ADDENDUM NO. 01 **Dated: June 30th, 2023**
Opening Date: July 13th, 2023 @3:00 pm

Project No.: 16368E-02-03
Description: Kingsessing Recreation Center Building & Site Improvements Package 2: Interior Envelope Repairs & Improvements

1 E202-R.2 ELECTRICAL PROPOSED POWER - REC CENTER SECOND FLOOR
1/8" = 1'-0"

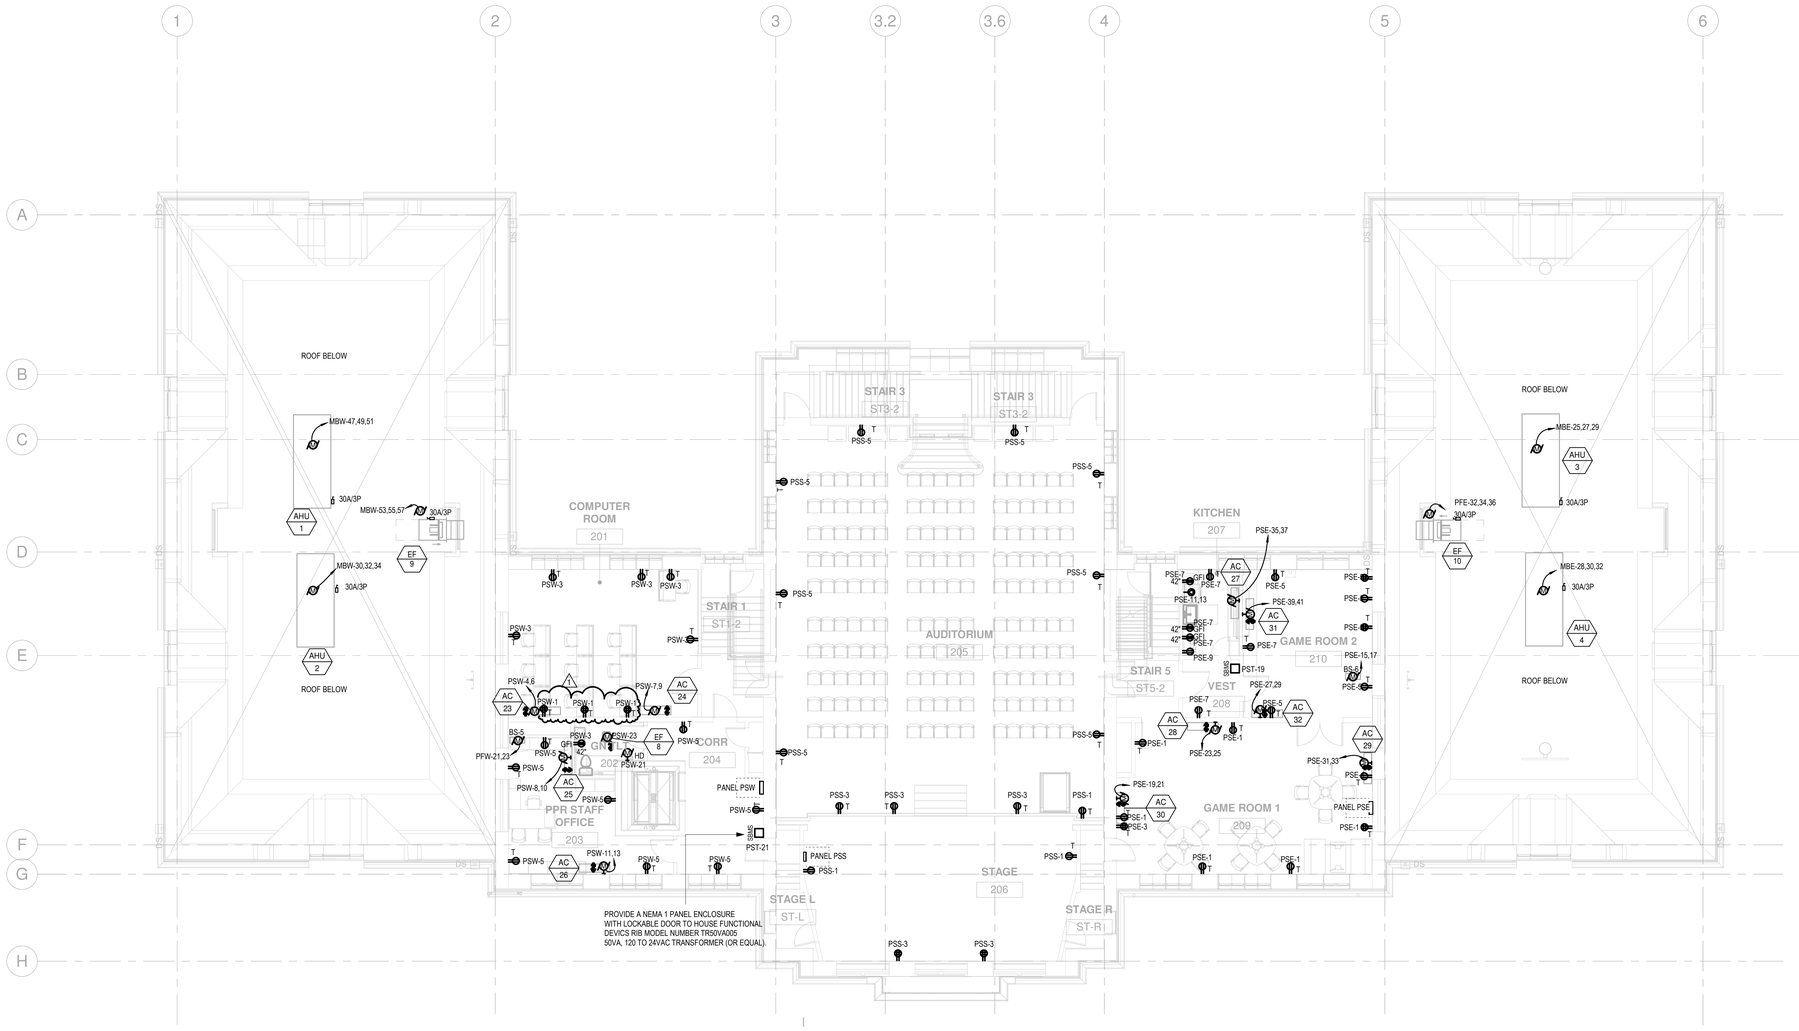
E501-R.2	ELECTRICAL SCHEDULES	RE: Provided circuiting information in the new Panel MLB for the existing receptacles for pool chemical feeders.
E202-R.2	PROPOSED PLAN - SECOND FLOOR	REV: Floor receptacles are moved to the walls to accommodate new furniture layout in computer room. DEL: Some convenience receptacles on the walls of the computer room are removed.
P201-R.2	PLUMBING PROPOSED DRAINAGE – FIRST FLOOR	REV: Added a note to clarify water fountain drainage.
P301-R.2	PLUMBING PROPOSED SUPPLY – FIRST FLOOR	REV: Changed note remove “refer to arch” and add equipment callout.
P401-R.2	PLUMBING SUPPLY RISER BASE SCOPE	REV: Updated riser with correct fixture tag.
P401B-R.2	PLUMBING SUPPLY RISER DEDUCT ALT	REV: Updated riser with correct fixture tag.
P401C-R.2	PLUMBING SUPPLY RISER ADD ALT.	REV: Updated riser with correct fixture tag.
P500-R.2	PLUMBING SCHEDULES	REV: Added drinking fountain spec and notes.
